# SERVICE BULLETIN

Ride: TRABANT

Subject: REPLACEMENT OF FLOOR CLEVIS  
FOR LIFT CYLINDERS

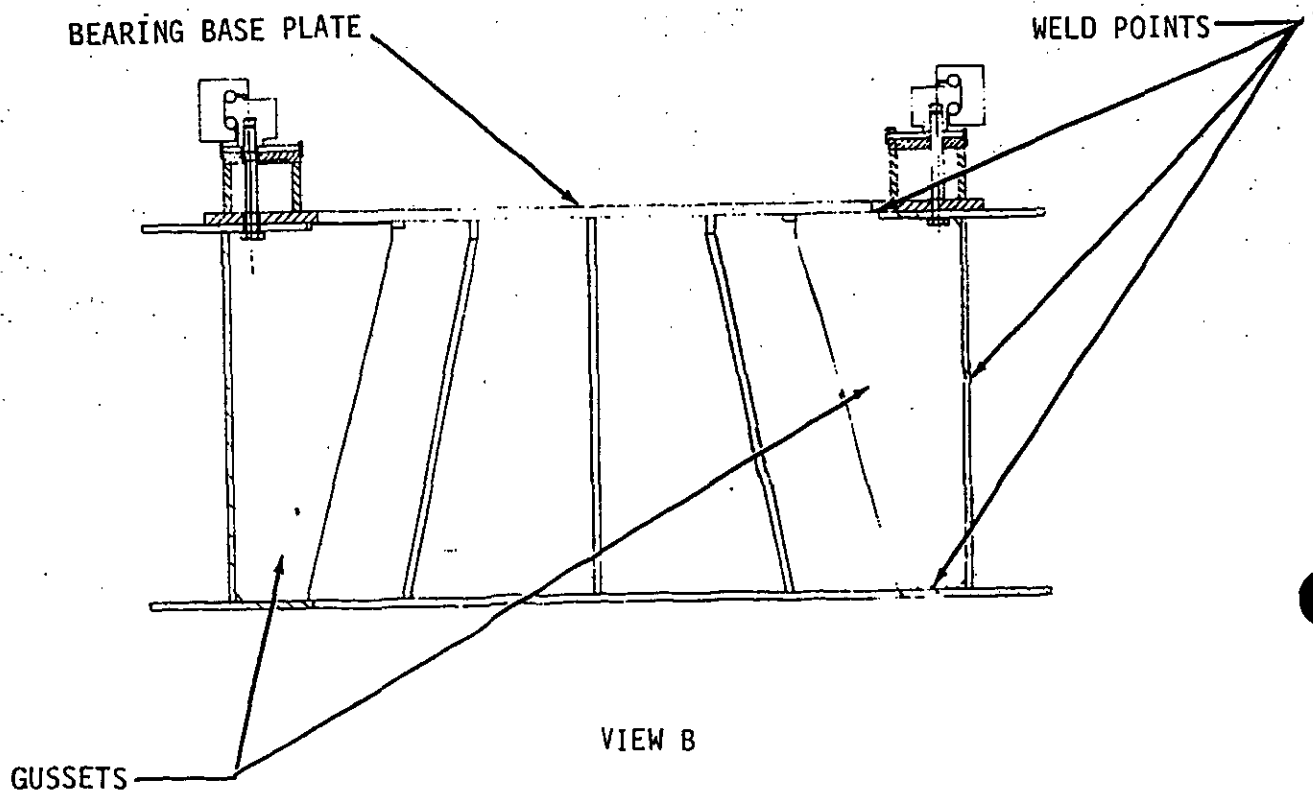
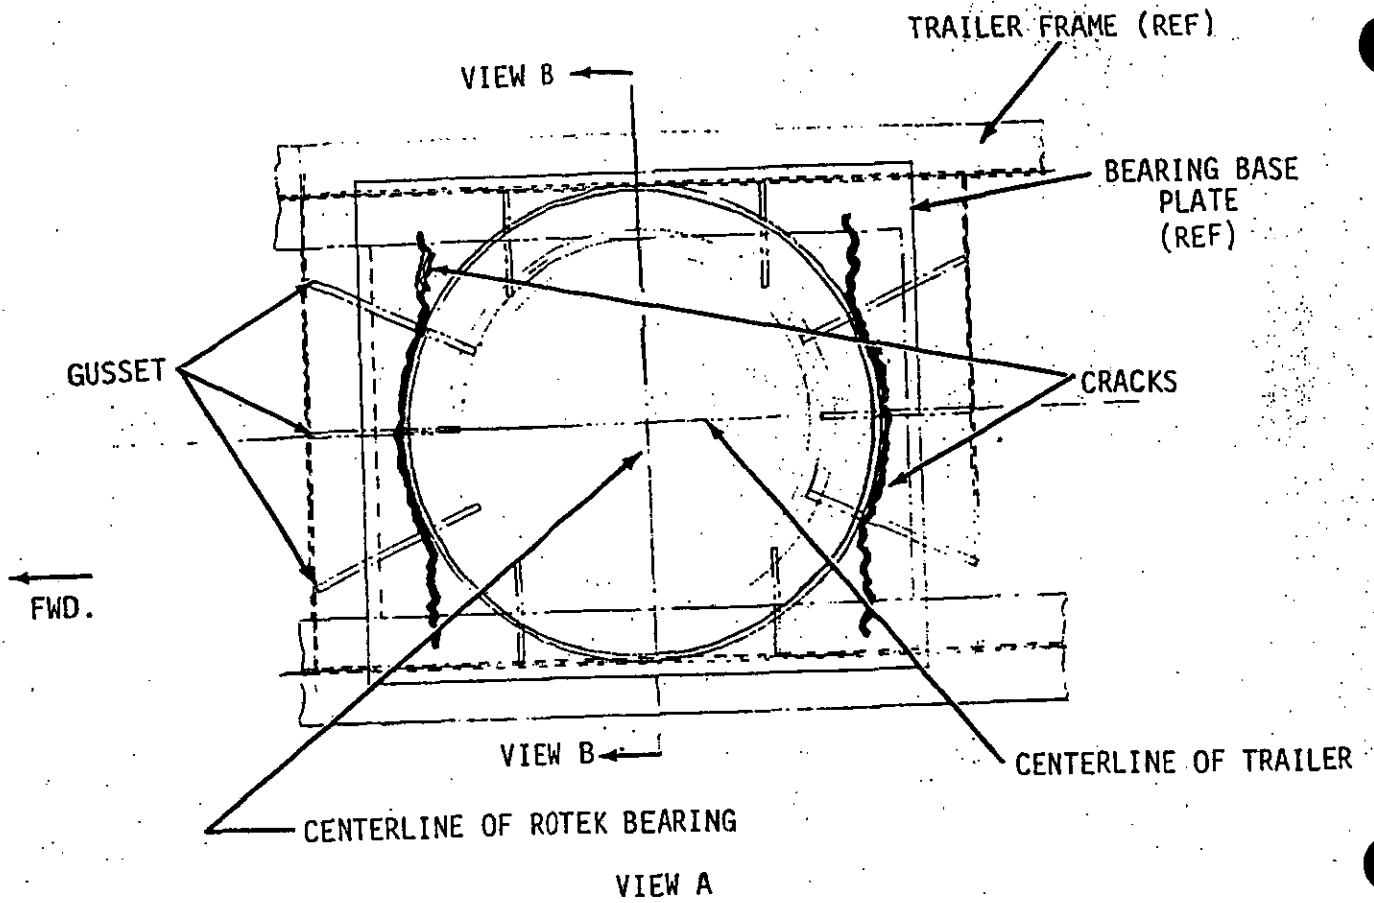
There is a possibility that cracks may form laterally on the bearing base plate in the positions indicated in VIEW A below or along seams where gussets are welded to the trailer frame or bottom of the bearing base plate as shown in VIEW B.

NOTE: To facilitate finding lateral cracks in the bearing base plate, rock the upper wheel assembly parallel to the center line of the trailer while observing the areas indicated in VIEWS A AND B. If cracks exist, they will be accentuated by the rocking motion.

FIGURE A

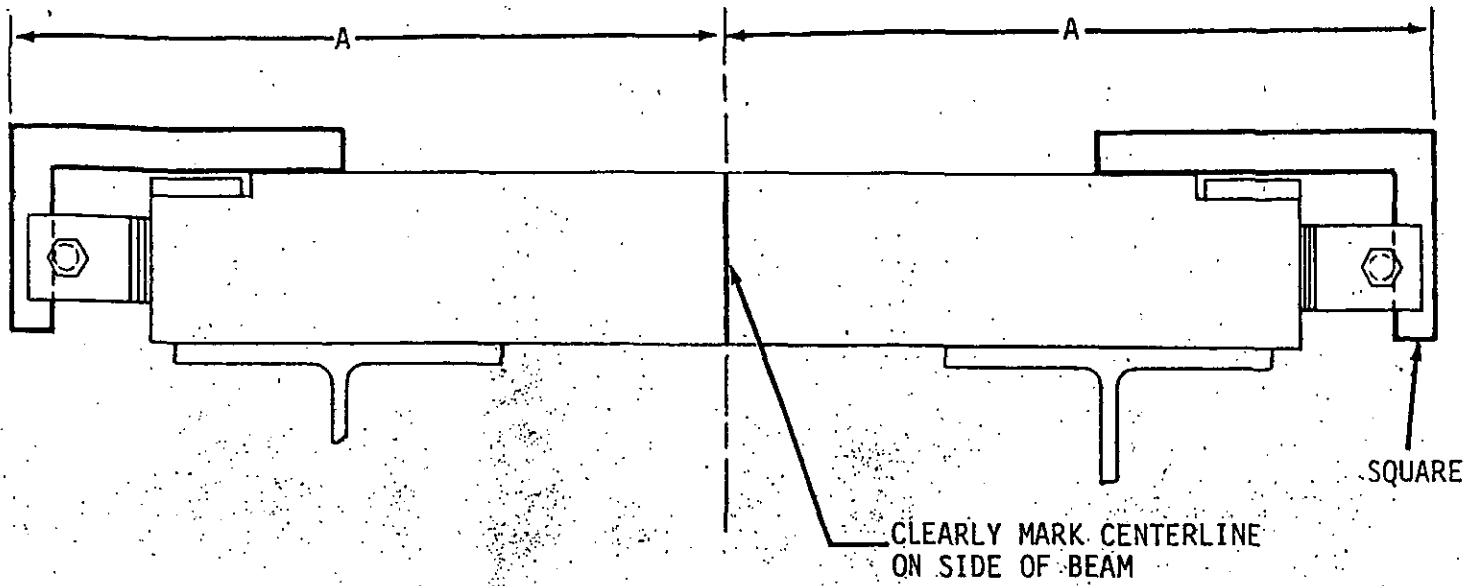
With the ride set up remove the floor lift cylinders from the clevises. Replace the bolts in the clevises and lay a square at each end of the crossmember, tight against the bolts. Measure the distance between the two squares to find the centerline as shown in FIGURE A. Clearly mark the centerline on the side of the crossmember. Remove and discard the clevises, nuts and bearings. Cut the crossmember as shown in FIGURE B and grind the cuts smooth. Do not remove the lower wall of the crossmember.

VIEW FROM UNDER BOOM  
FIGURE C

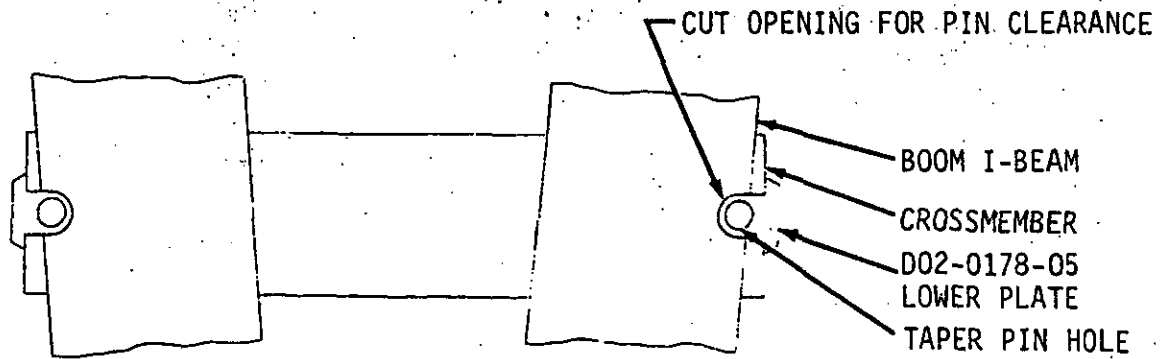
Use the centerline mark to center the D02-0178-05 lower plate in the crossmember. Mark the taper pin holes on the crossmember and remove the lower plate. Cut the crossmember and the I-beams for pin clearance as shown in FIGURE C. Grind cuts smooth.

FIGURE F

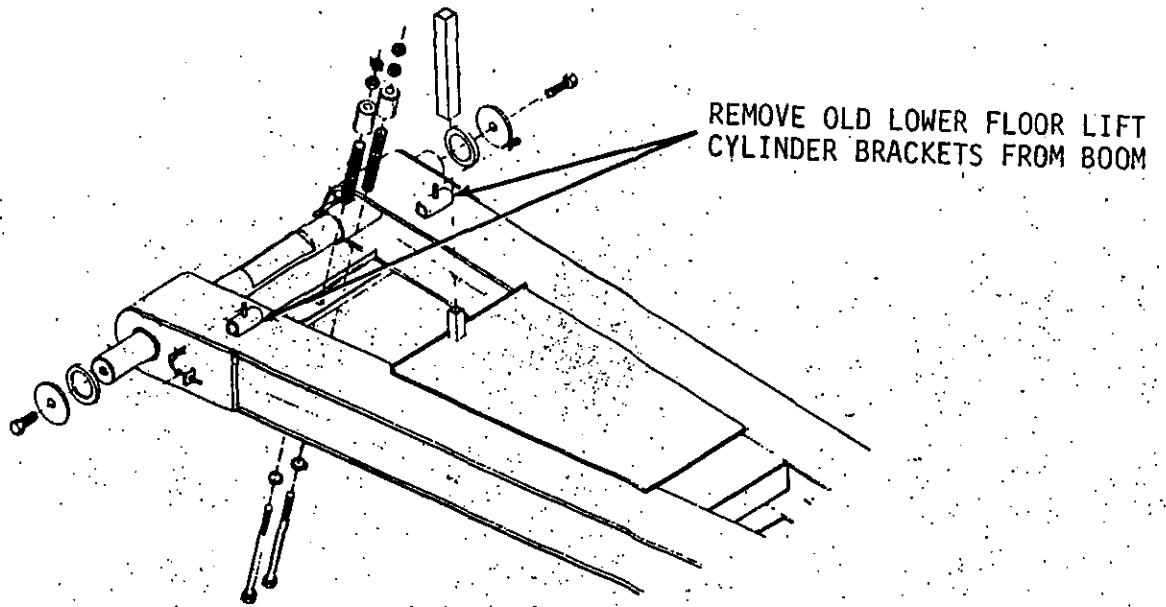
Cut the old lower floor lift cylinder brackets off of the boom (See FIGURE F) and grind the area smooth. Retract the cylinder rods and secure the 1030600-3 cylinder mounts to the cylinders using the 390-51975 taper pins and 694-51900 hair pins. Position the cylinder mounts and the 1030600-4 stops as shown in FIGURE G and tack weld them to the boom. Remove the floor lift cylinders from the cylinder mounts and weld the clamp brackets and the stops to the boom as shown in FIGURE G. Secure the floor lift cylinders in the cylinder mounts using the bolts and nuts.

## INSTALLATION OF SPRING

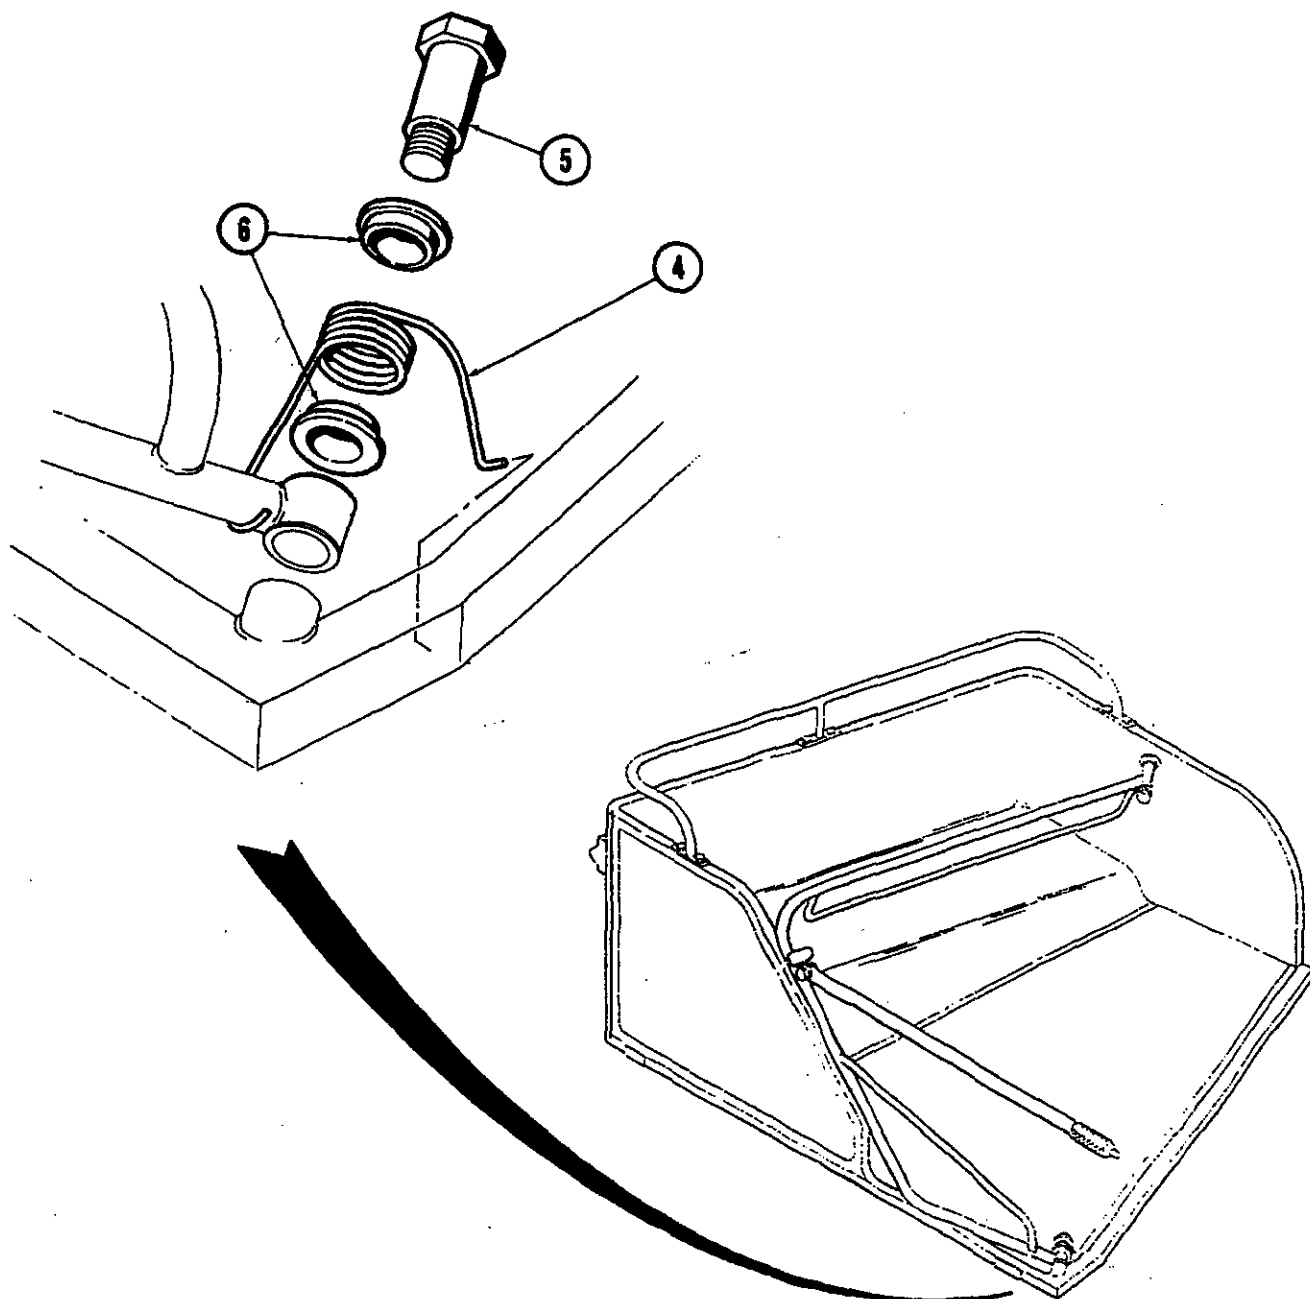
1. Remove old stripper bolt and discard.
2. Place a spacer (item 6) into each end of the spring (item 4).
3. Slip spring and spacers onto new stripper bolt (item 5). Apply anti-seize material to the threads of the bolt.
4. Slip stripper bolt back through lap bar and attach spring to lap bar and to bottom of seat frame.
5. Secure stripper bolt to seat frame with 45 to 54 foot pounds of torque. The spring must not be in a bind when the bolt has been secured.

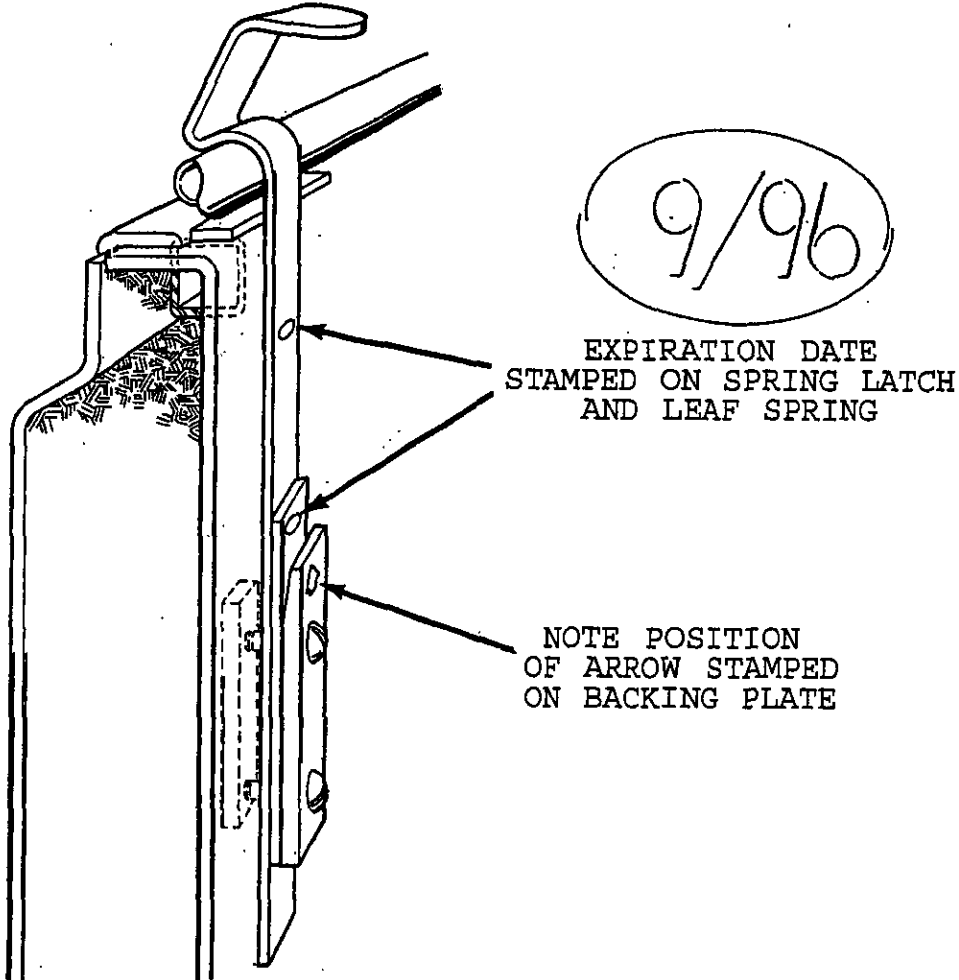
Chance Rides, Inc., through testing and design change, has developed a new spring latch assembly for the lap bar on the seat of the above noted TRABANT/CASINO amusement rides. This new spring latch assembly makes use of a new style backing plate, a new leaf spring, and a spring latch. This design extends the life of the spring latch.

IMPORTANT: The spring latches, leaf springs and backing plates must be installed exactly as shown in this bulletin.
